Tennessee Valley Authority

NUREG-0847
Supplement No. 5

Safety Evaluation Report

related to the operation of
Watts Bar Nuclear Plant,
Units 1 and 2

Figure 17.1 TVA organization for Watts Bar nuclear QA
 (Based on TVA Nuclear Quality Assurance Plan, dated February 15, 1990)

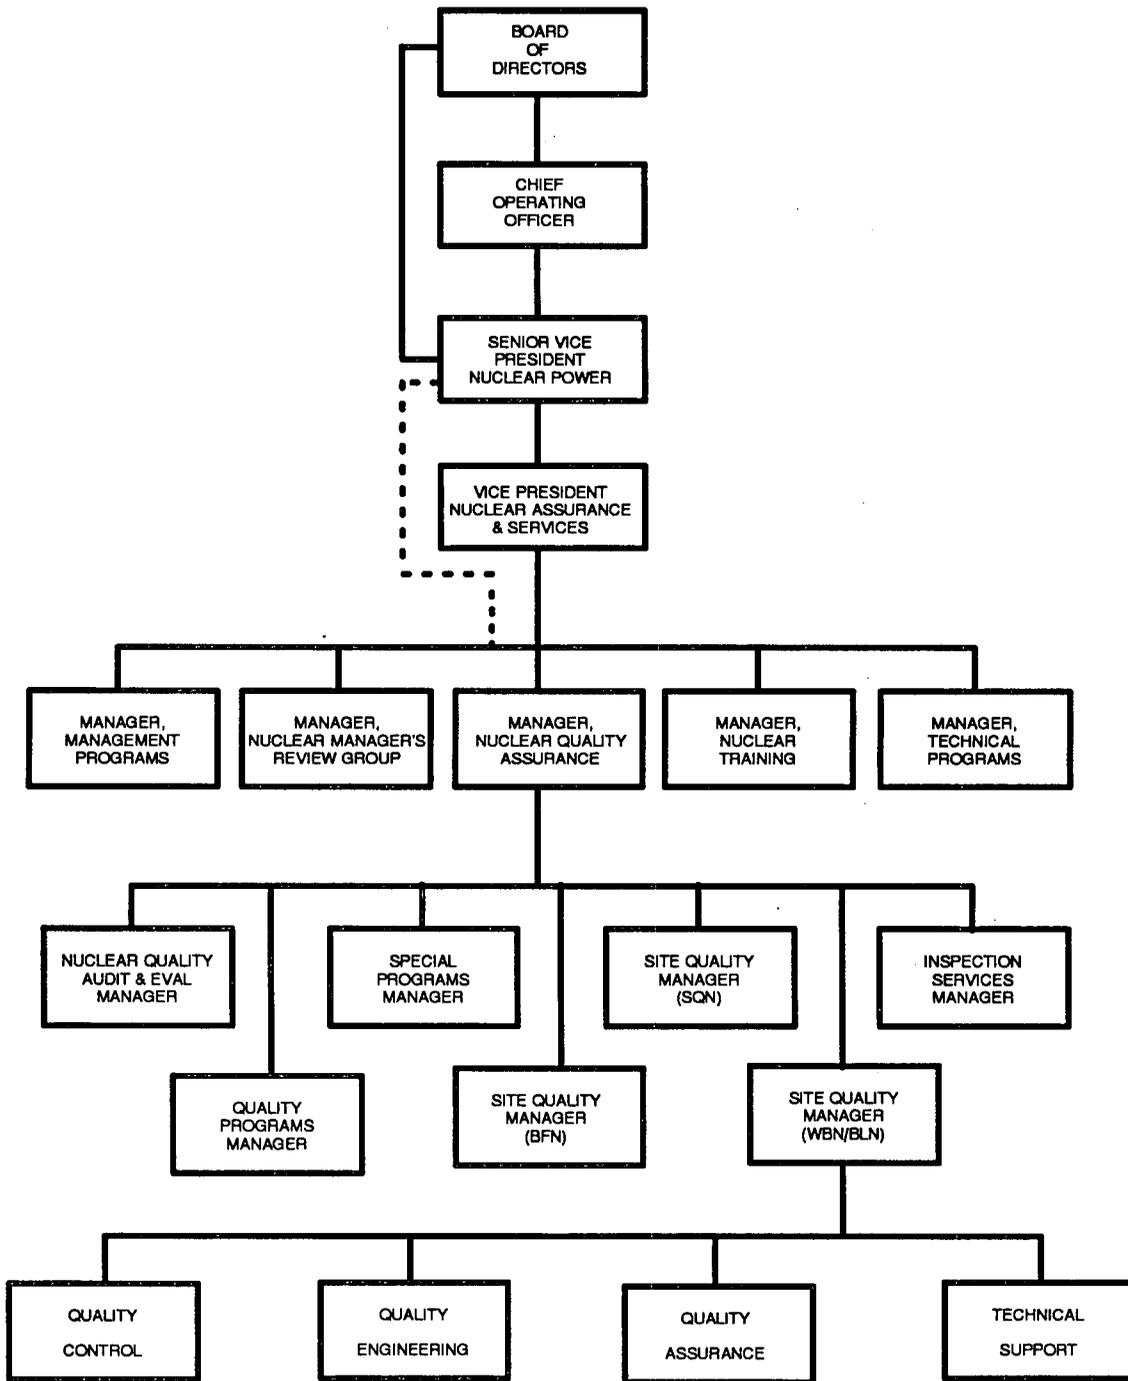
As shown on Figure 17.1, five managers report to the Vice President, Nuclear Assurance and Services. Each of these managers has specific QA responsibilities. The Manager, Management Programs is responsible for QA reports, configuration management, and computer software. The Manager, Nuclear Training is responsible for the indoctrination and training programs.
